**LEVY NUCLEAR POWER PLANT, UNITS 1 AND 2
DOCKET NOS. 52-029 AND 52-030
SUPPLEMENT 1 TO RESPONSE TO REQUEST FOR ADDITIONAL INFORMATION LETTER
NO. 020 RELATED TO IDENTIFICATION OF POTENTIAL HAZARDS IN SITE VICINITY**

**Levy Nuclear Power Plant Units 1 and 2
Supplement 1 to Response to NRC Request for Additional Information Letter No. 020
Related to SRP Section 2.2.1-2.2.2 for the Combined License Application,
Dated March 6, 2009**

NRC RAI NUMBER: 02.02.01-02.02.02-2

Revised FSAR Figure 2.2.1-204 (Rev 1 Draft) – Airports and Airways (Sheets 1, 2, and 3)

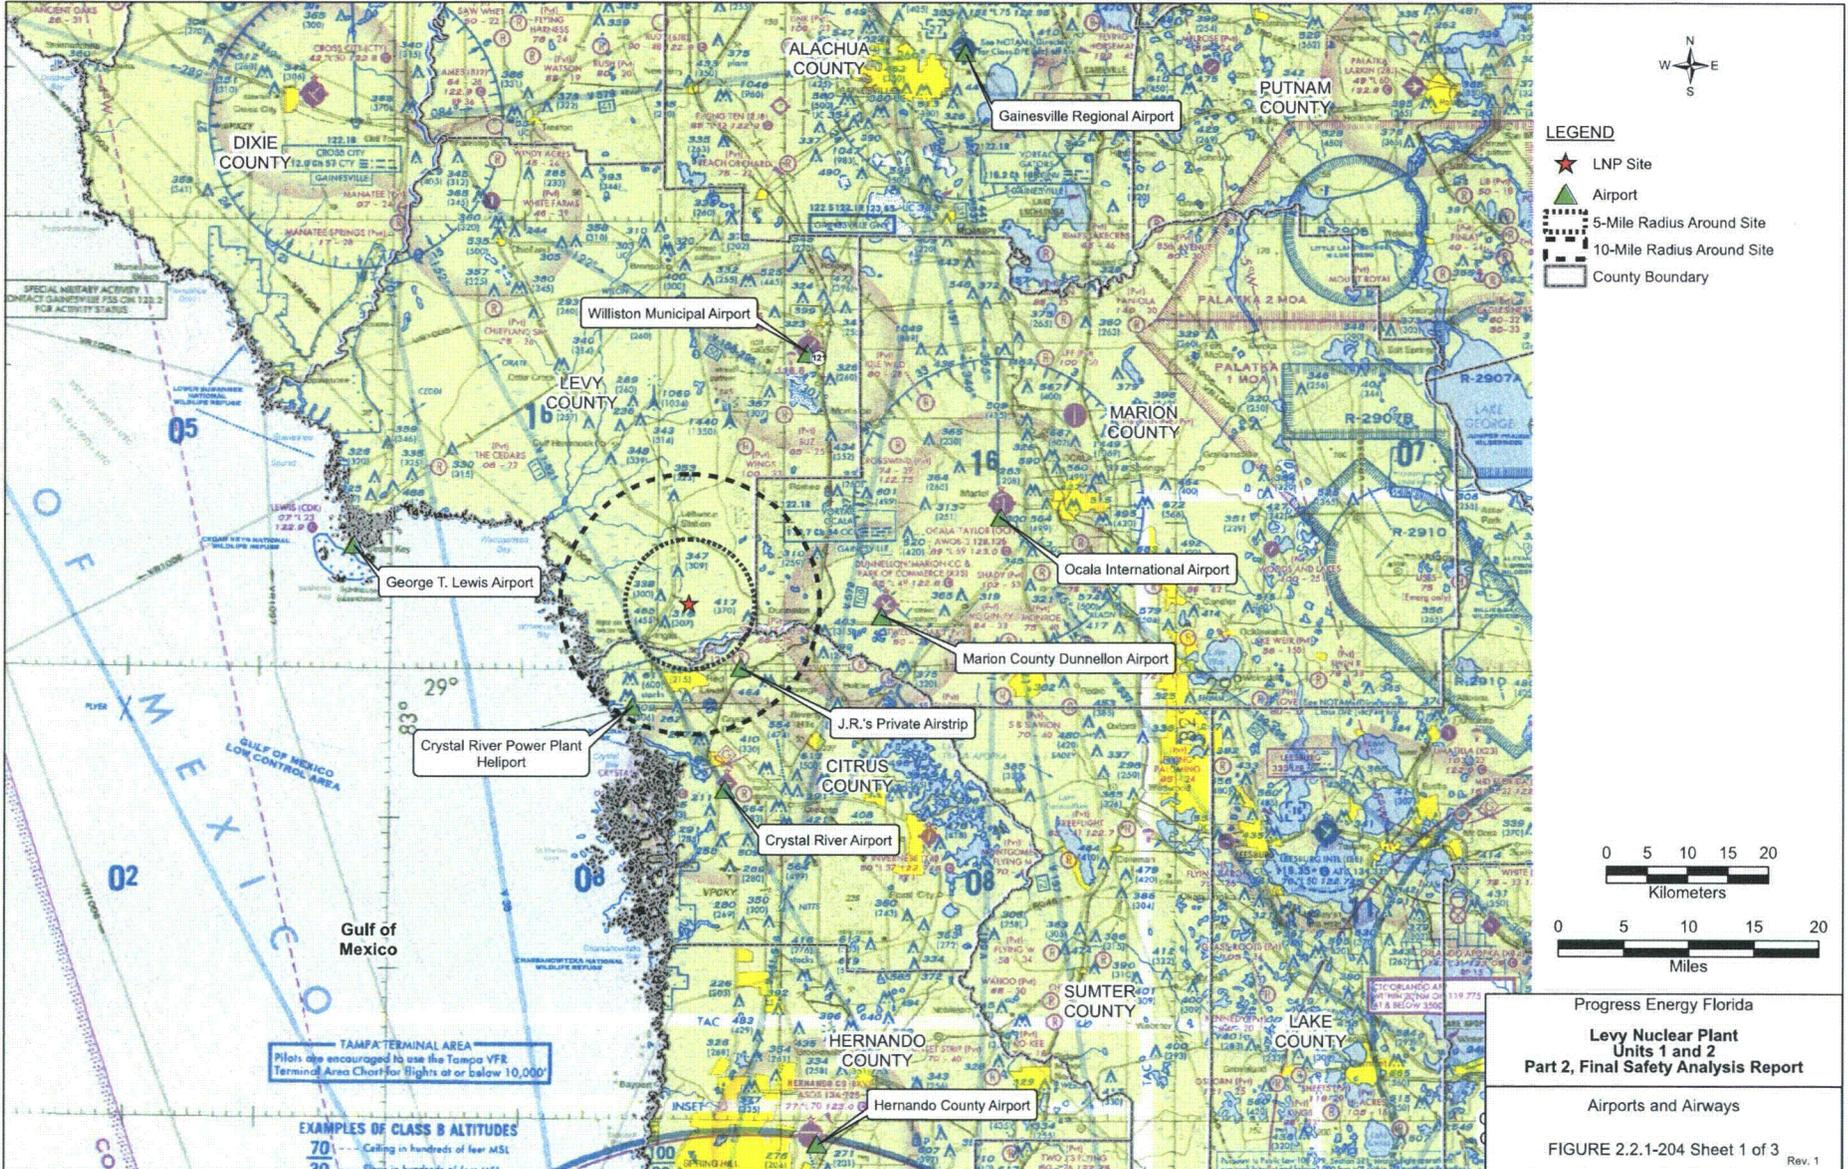
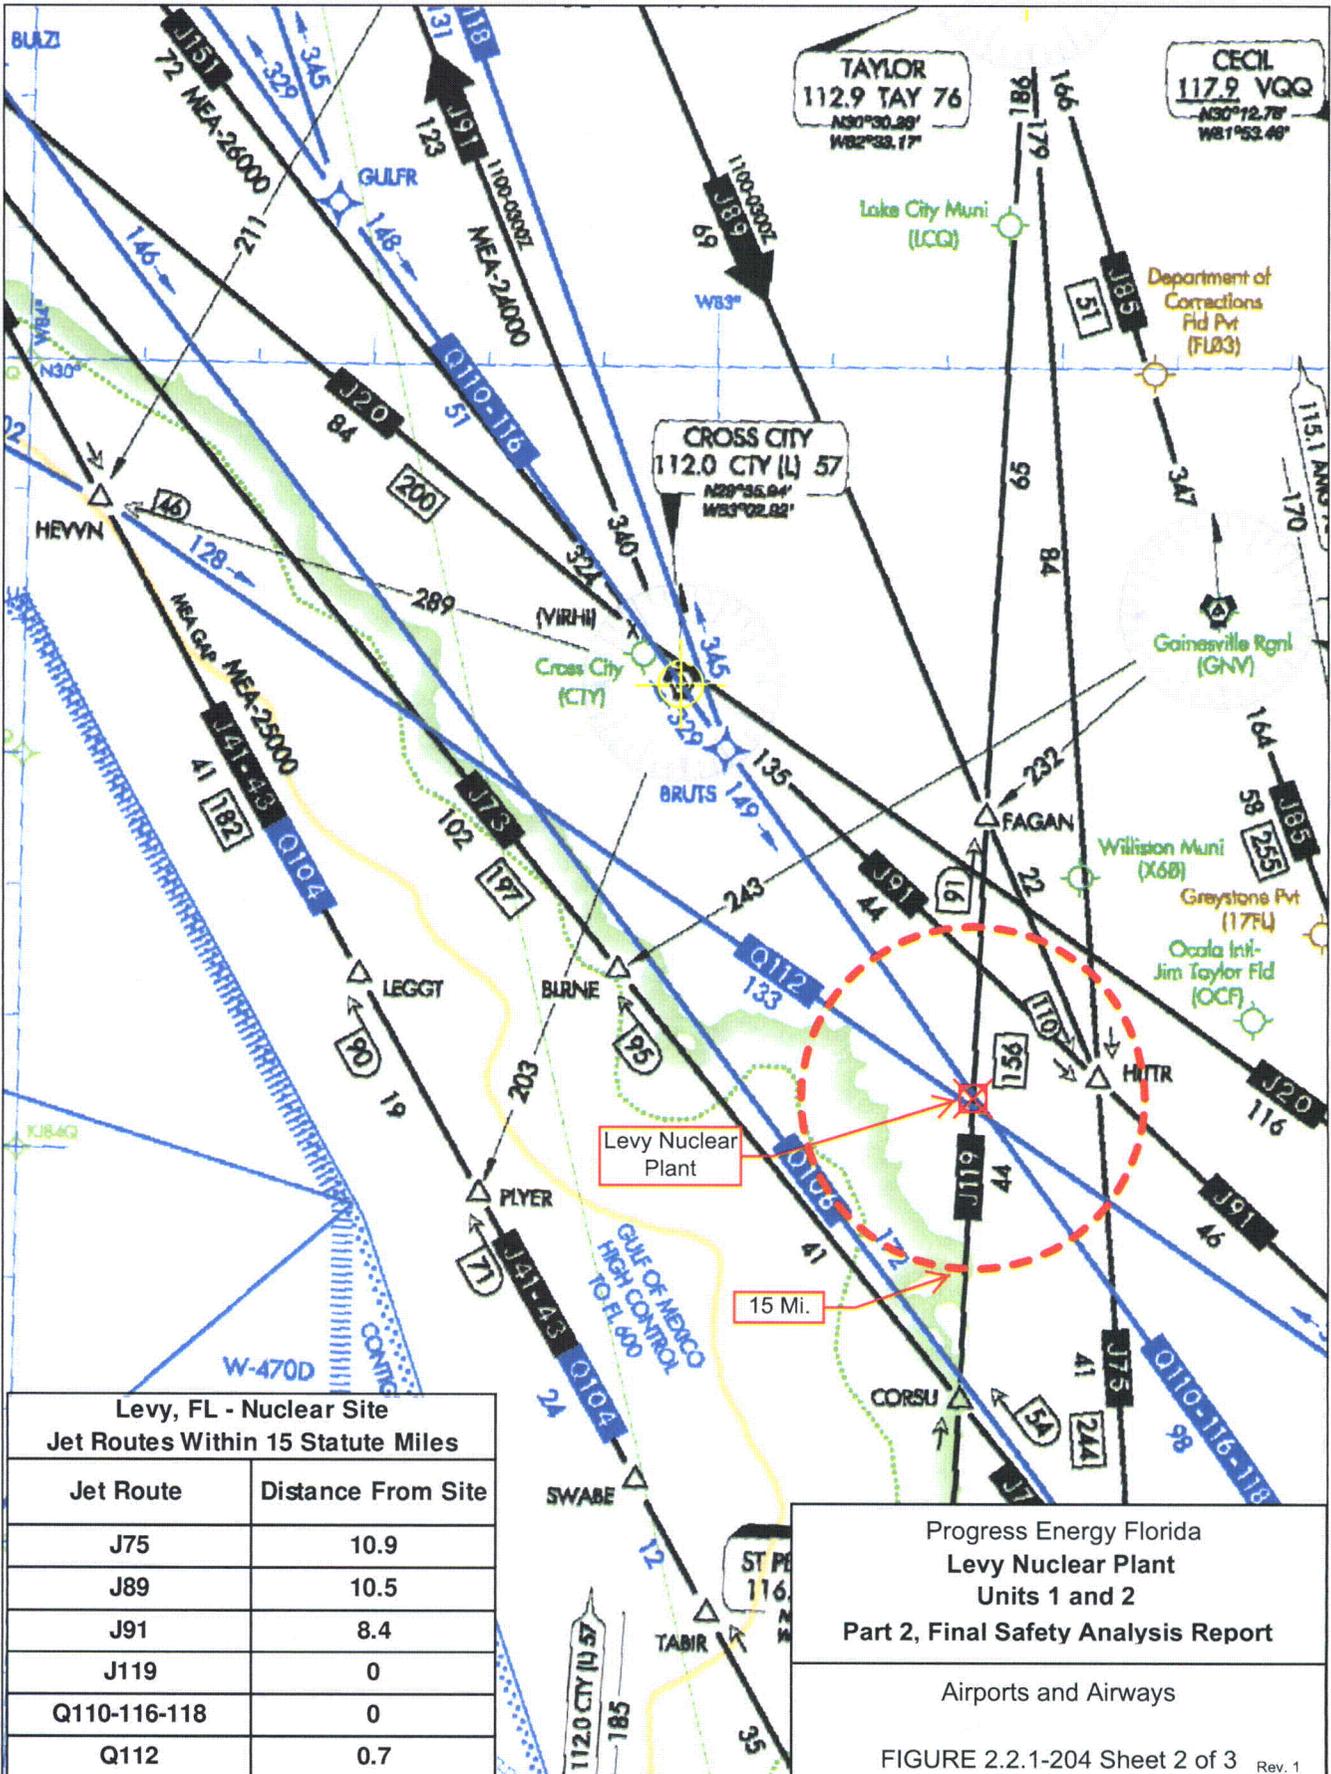
RG 1.206 provides guidance regarding the information that is needed to ensure potential hazards in the site vicinity are identified and evaluated to meet the siting criteria in 10 CFR 100.20 and 10 CFR 100.21. The NRC Staff's review of FSAR Sections 2.2.2.7 and 3.5.1.6 indicates that there two 8 mile wide Federal Victor Airways, VR 1006 and V7-521, whose center line are within 4 miles of the LNP site. Therefore, in accordance with the acceptance criteria for FSAR Section 3.5.1.6, the aircraft hazards associated with these Victor Airways should be evaluated and addressed in Section 3.5.1.6. Please provide an evaluation of each, or provide a justification for their exclusion.

“The outer boundaries of five airways are routed within 2 miles of the LNP site: V7-521, VR 1006, J119, Q110-116-118 and Q112 (shown on Figure 2.2.1-204).”

The outer boundary of five airways is routed within 2 miles of the LNP site: V7-521, VR 1006, J119, Q110-116-118 and Q112 (shown on Figure 2.2.1-204). Thus, an aircraft hazards evaluation needs to be performed for LNP 1 and 2.

5. Replace FSAR Figure 2.2.1-204, in its entirety, with the version listed under **Attachments/Enclosures** below. A second and third sheet have been added to Figure 2.2.1-204 that indicates the routes of Airways V7-521, J119, Q110-116-118 and Q112.
